COPPER RIDGE
MASTER DEVELOPMENT PLAN
JULY 2005

MDP # 863

1. Need to associate residential area located above the Unit 10 with a development phase.
See attached revised MDP, that area is included with Unit-9.
2. Need to associate areas labeled Community Park with a development phase as per UDC 35-503(f).
Please see attached revised MDP.
3. Need to associate area labeled Recreation Center with a development phase as per UDC 35-503(f).
Please see attached revised MDP.
4. Need to associate areas labeled Commercial I, II, III with a development phase as per UDC 35-503(f).
Please see attached revised MDP.
5. Applicant also needs to provide legal descriptions concerning adjacent property owners as per UDC 35-B101(b)(2).
Please see attached revised MDP.

TO: Mia Herbold, P.E., M.W. Cude Engineers, L.L.C.
FROM: Ismael B. Segovia, Planner II, Development Services Department
DIVISION: Master Development Plan
COPIES TO: Michael Herrera, Special Projects Coordinator, Development Services Department
SUBJECT: Copper Ridge Master Development Plan

Redline 12/13/05

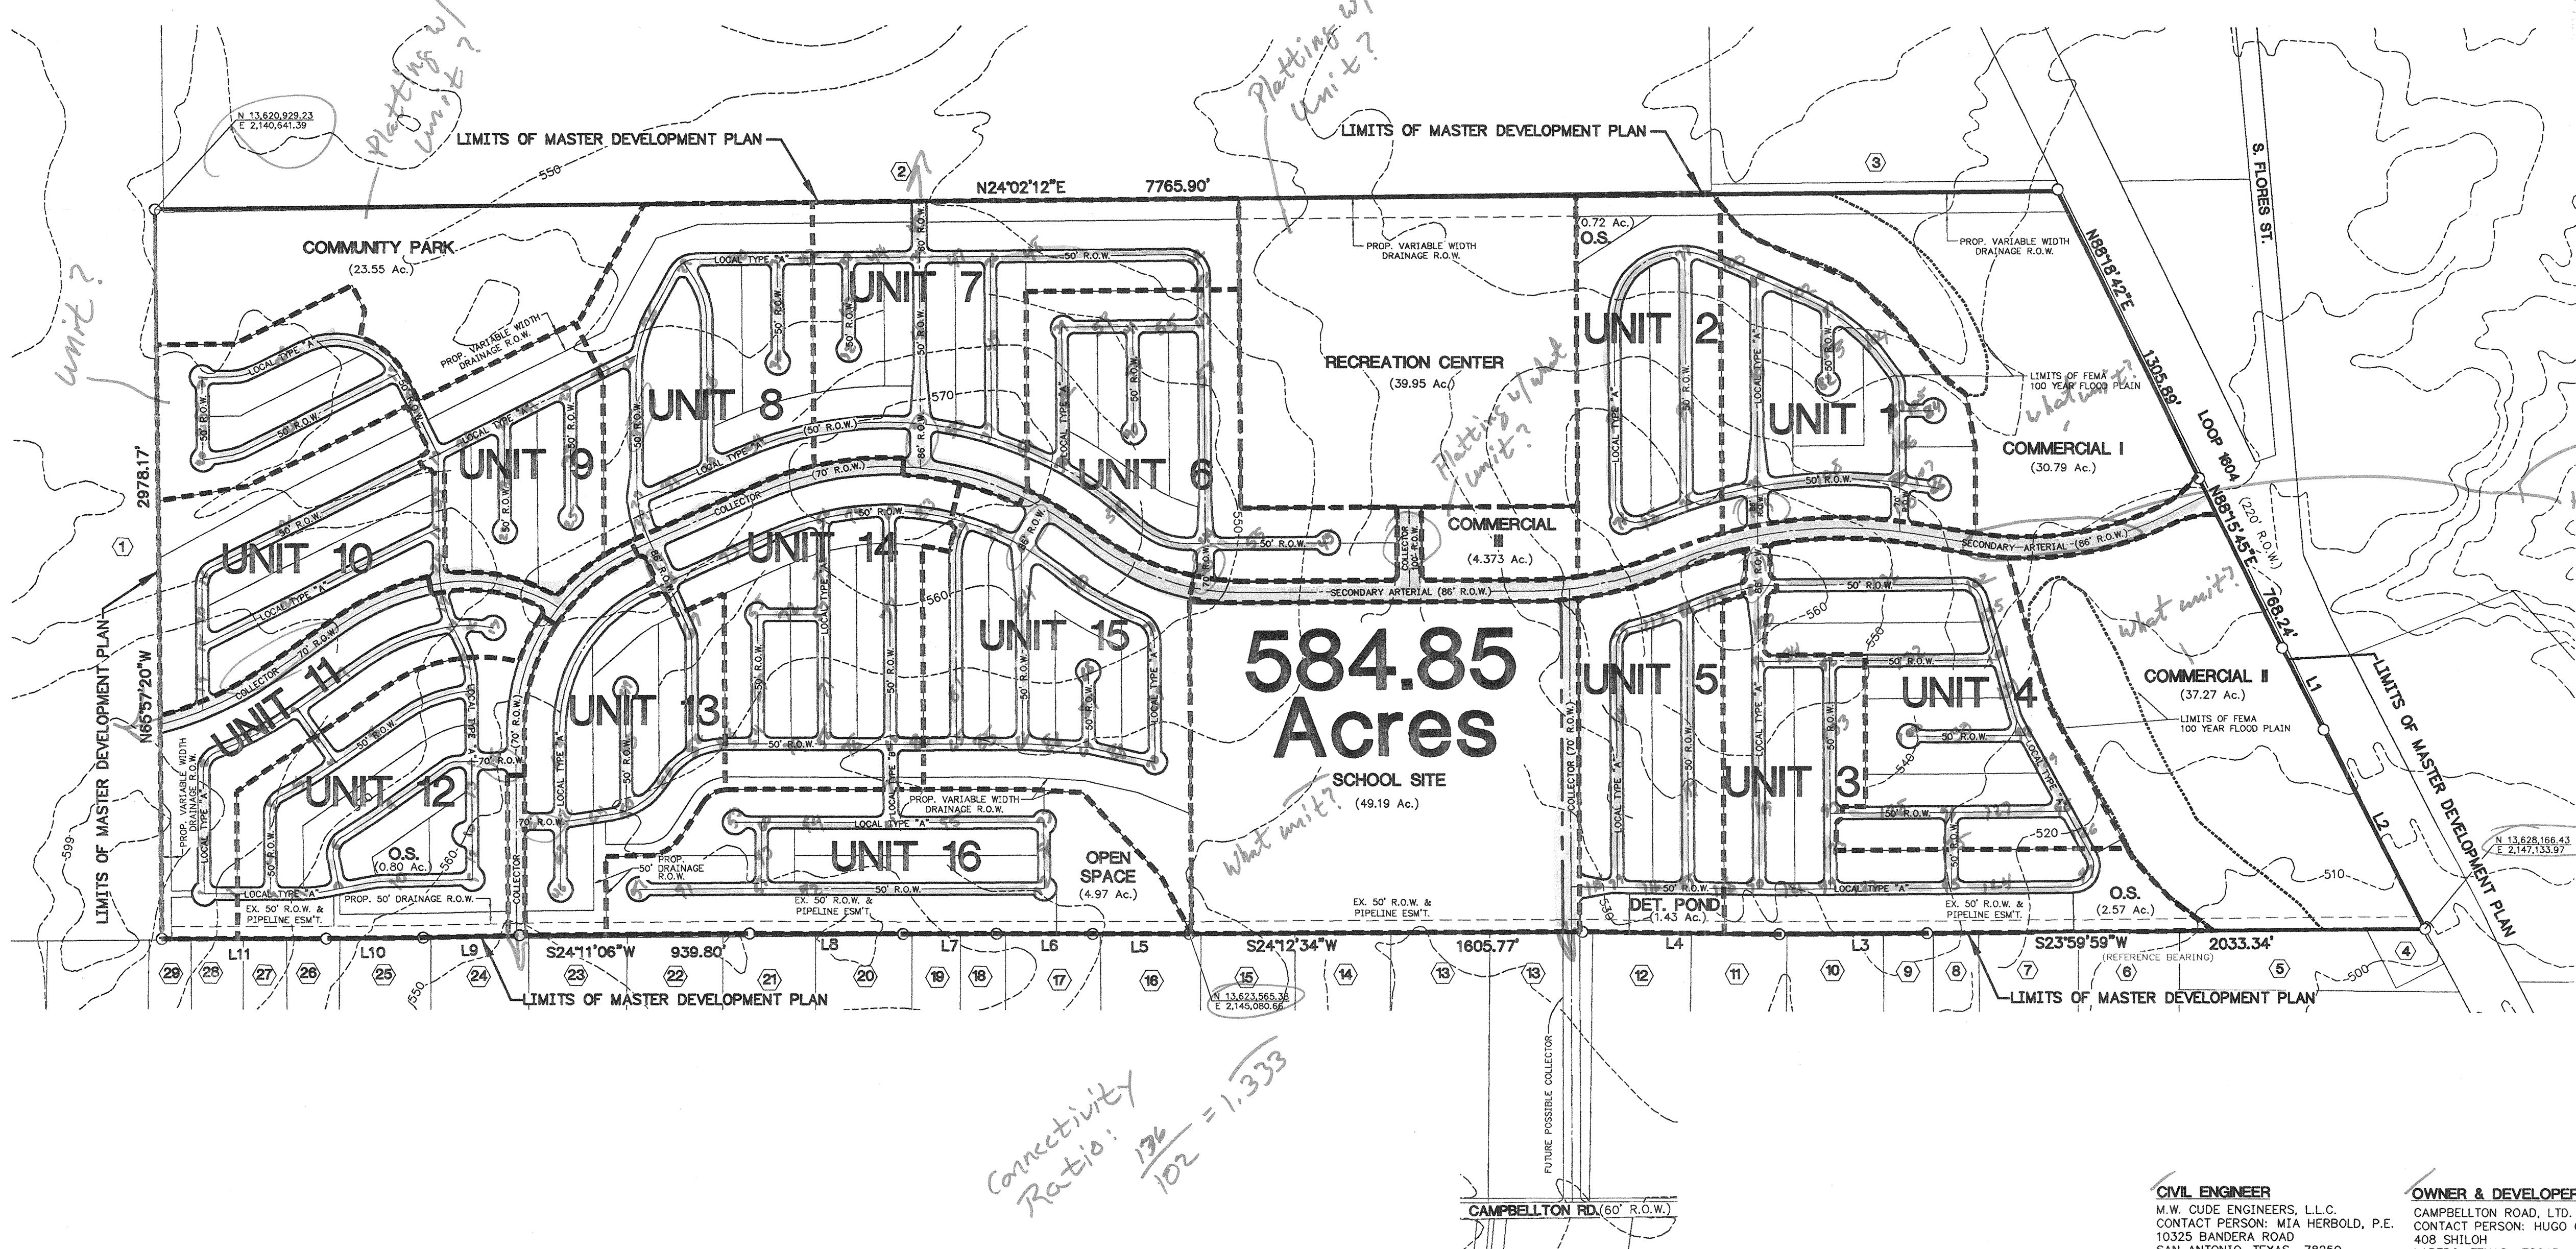
Does Work due to width of entrance

Hierarchy of Roadway

< 35-506(d) Table 506-1

Primary Arterial 120'

- going from Freeway to Secondary Arterial not allowed
